# UNITED STATES PATENT AND TRADEMARK OFFICE

09/901,079

Dong-Hoon Lee

## Office Action Summary

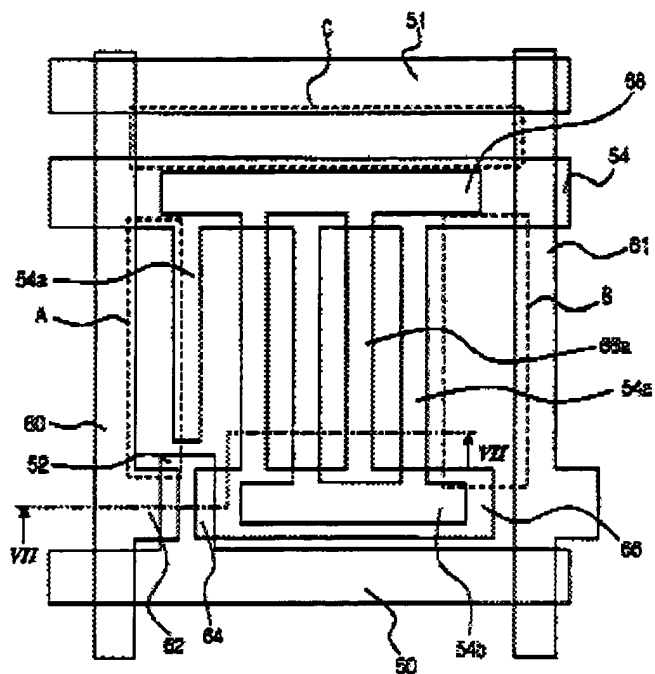
Sakamoto teaches 1), (entire patent, especially embodiment 2) in Drawings 3(a) and 3(b), the use of a common electrode, 3 (col. 8, line 23 through col. 10, line 7), on a protective overcoat layer, 12 (Applicant's the first passivation layer); an interlayer film, 13 (Applicant's second passivation layer) on the first passivation layer; and  
a pixel electrode, 14, on the second passivation layer to allow for manufacture of a color display that prevents color unevenness for better display performance (col. 4, lines 1-2).

Sakamoto is evidence that ordinary workers in the art of liquid crystals would find the reason, suggestion, or motivation to move the plurality of common electrodes of APA to be on and in contact with the first passivation layer; a second passivation layer on the first passivation layer; and  
a pixel electrode on the second passivation layer to allow for easy manufacture of a color display that prevents color unevenness for better display performance.

APA, Figure 7D:

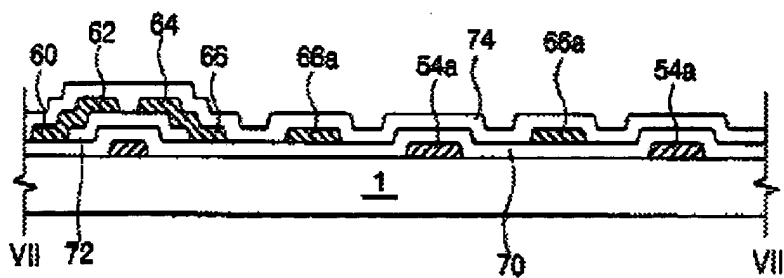
As to claim 7, APA discloses a device wherein the common line, 54, is parallel with the gate line, 50, and spaced apart from the gate line.

As to claim 8, APA discloses a device wherein the data line, 60, is perpendicular to the gate line, 50.

As to claim 9, APA discloses a device further comprising a thin film transistor at a crossover point of the gate line, 50, and the data line, 60.

As to claim 10, APA discloses a device wherein the thin film transistor includes a gate electrode, 52, an active layer, 72, and source, 62, and drain, 64, electrodes.

**FIG. 3(a)**

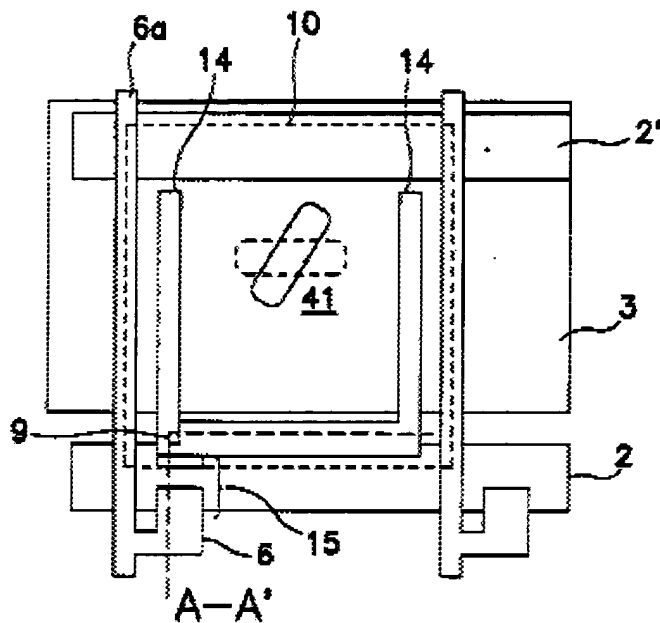
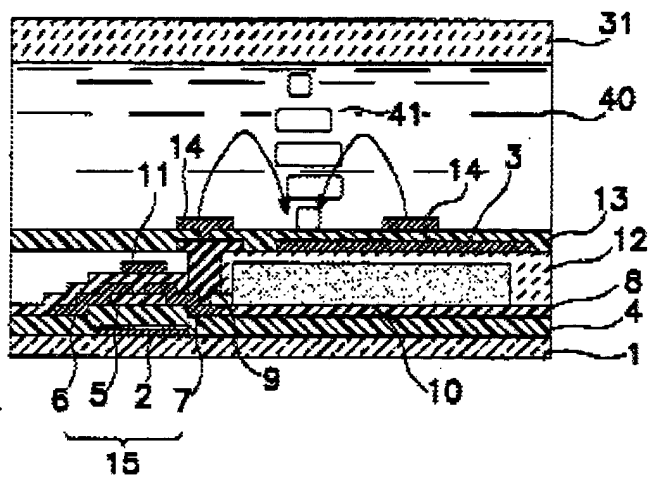
Sakamoto, as combined above, discloses a device wherein the first passivation layer includes a contact hole for connecting the pixel electrode (per Figure 3(b)).

As to claims 13 and 14, Sakamoto discloses a device wherein the second passivation layer includes a drain contact hole to electrically connect the pixel electrode to the drain (per Figure 3(B)).
